**CENTRAL CONNECTICUT UNIVERSITY - PHASE IV IMPROVEMENTS TO
RECREATION/ATHLETIC FIELDS, STADIUM SEATING AND SUPPORT FACILITIES
NEW BRITAIN, CONNECTICUT
PROJECT: BI- RC- 366**

BID OPENING	1:00 P.M.	AUGUST 25, 2010
ADDENDUM NUMBER 1	DATE OF ADDENDUM	AUGUST 16, 2010

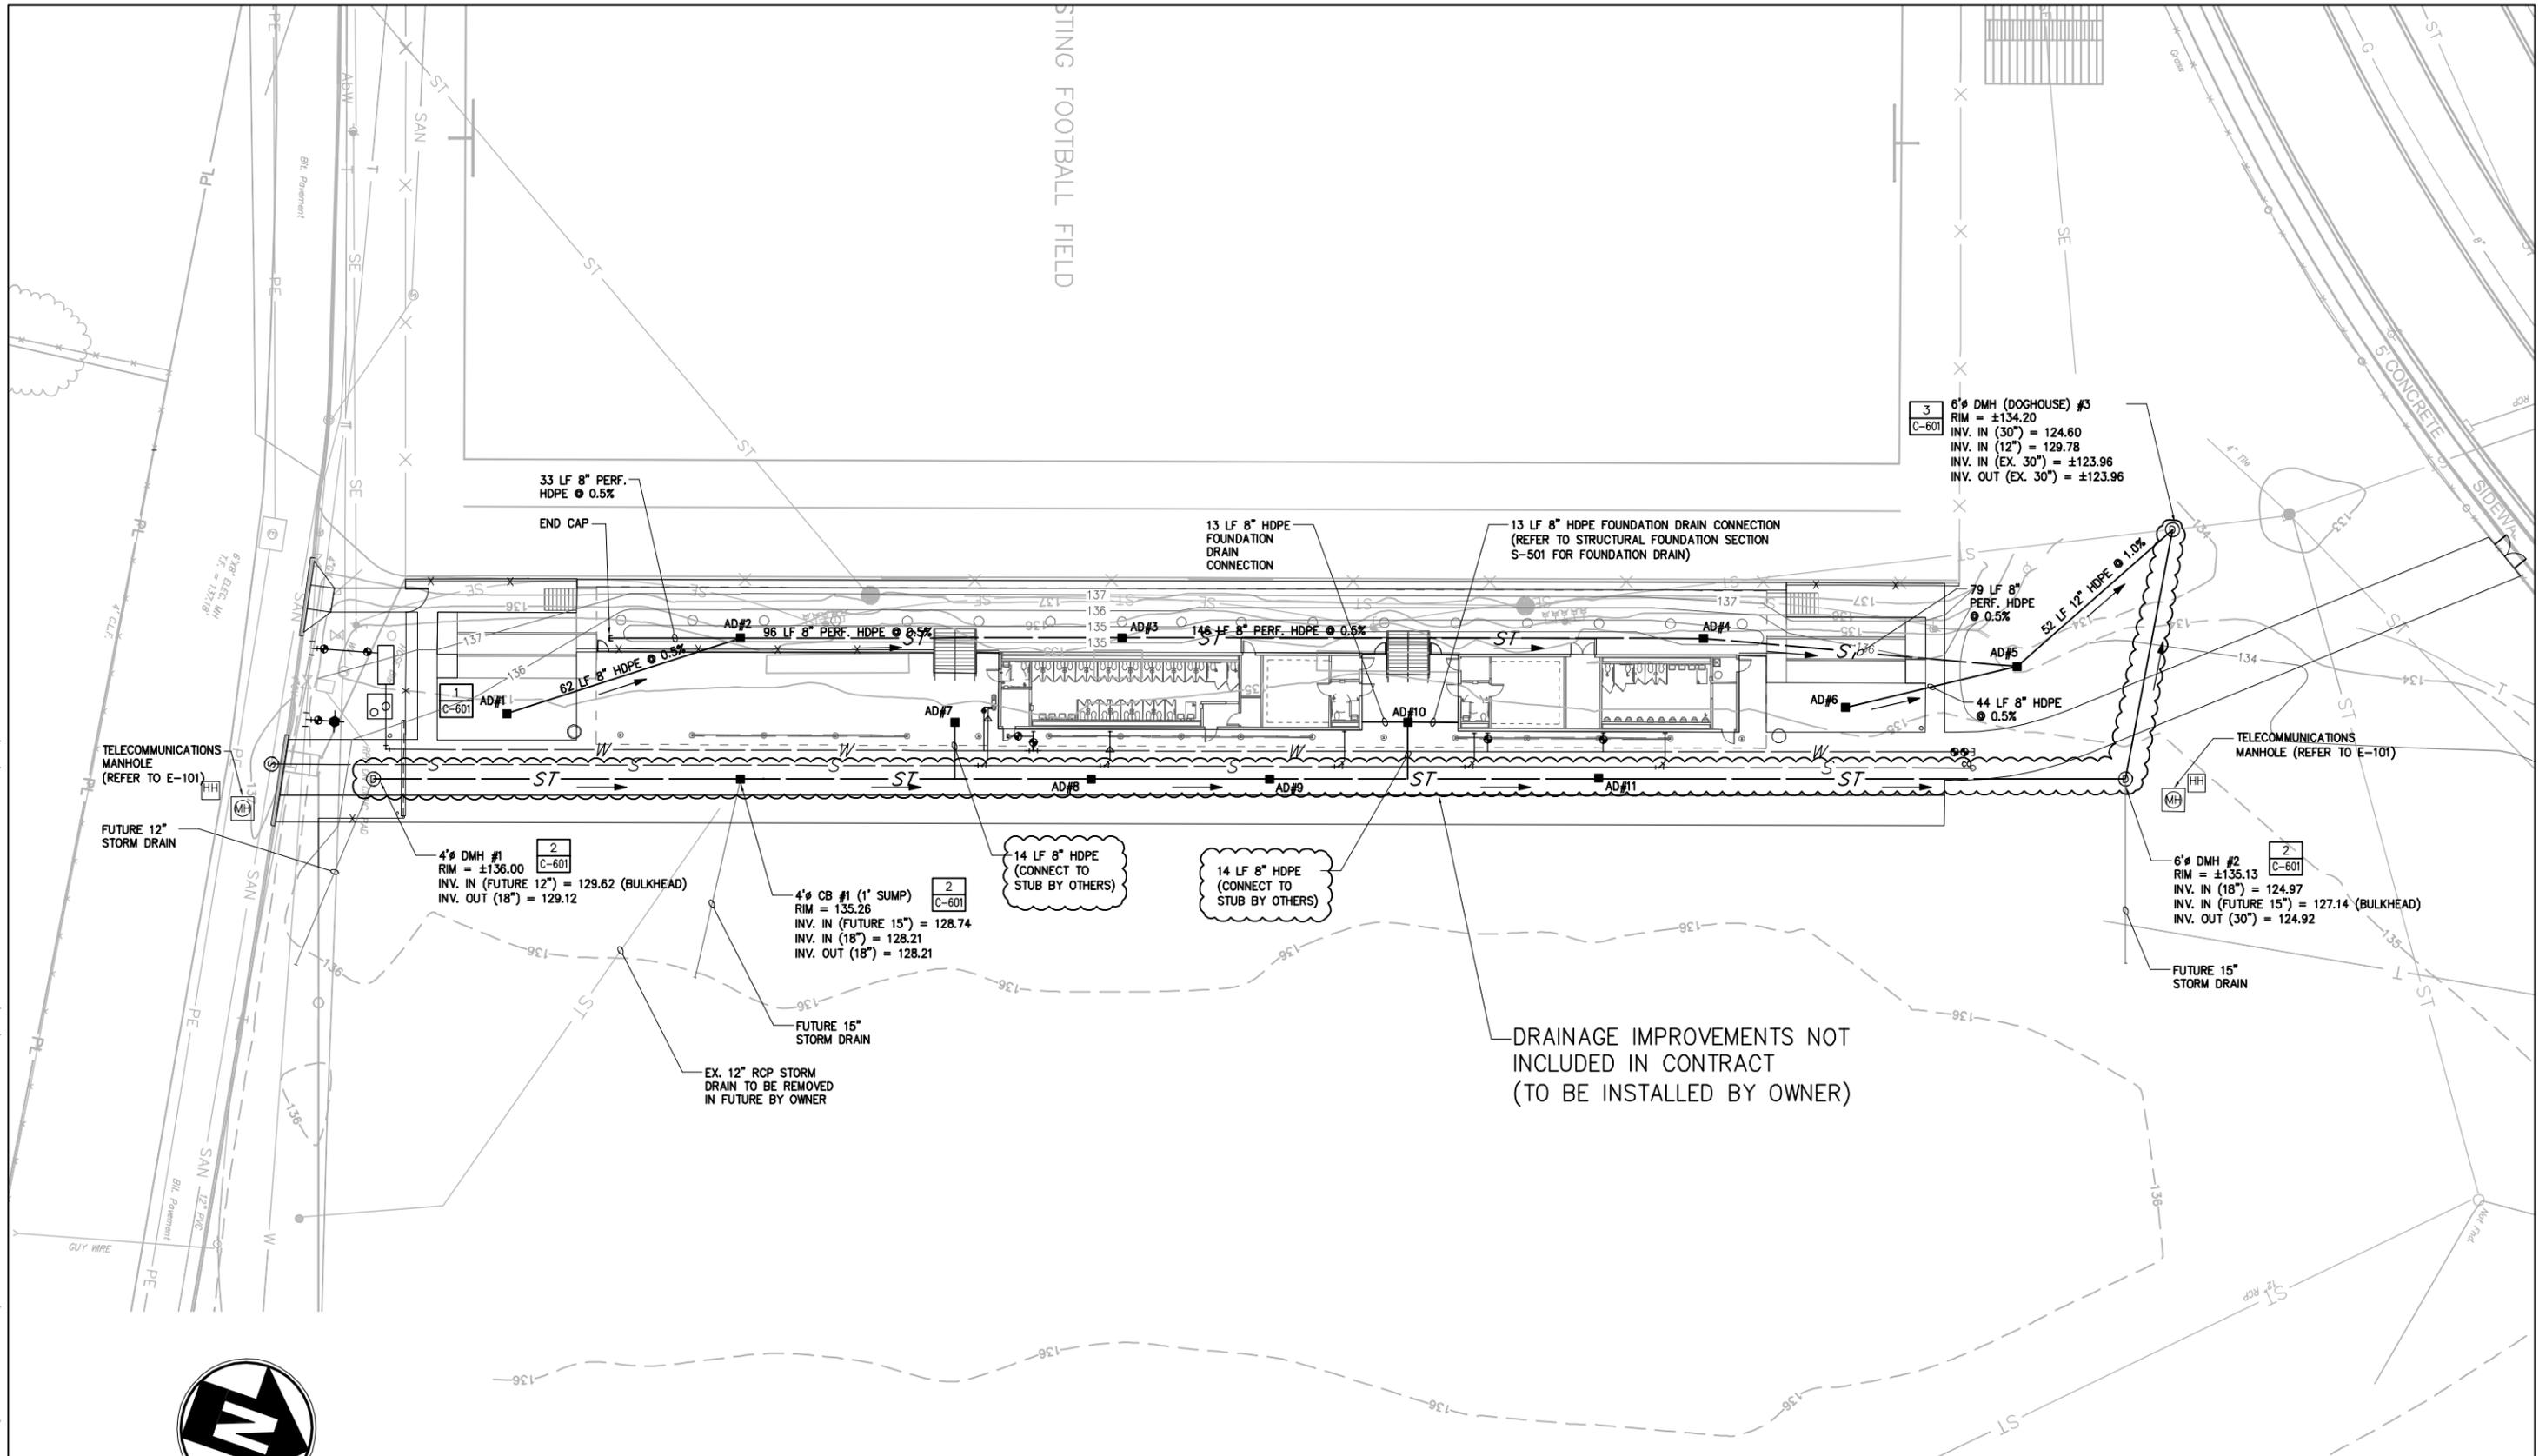
Refer to attached Sketch SK-01, dated 16 August 2010, for modifications to storm drainage improvements. The Owner intends to construct the main storm drainage improvements, including the noted catchbasins, manholes, area drains, and stubs for future Arute Field connections as part of the existing soccer field construction project, currently under construction.
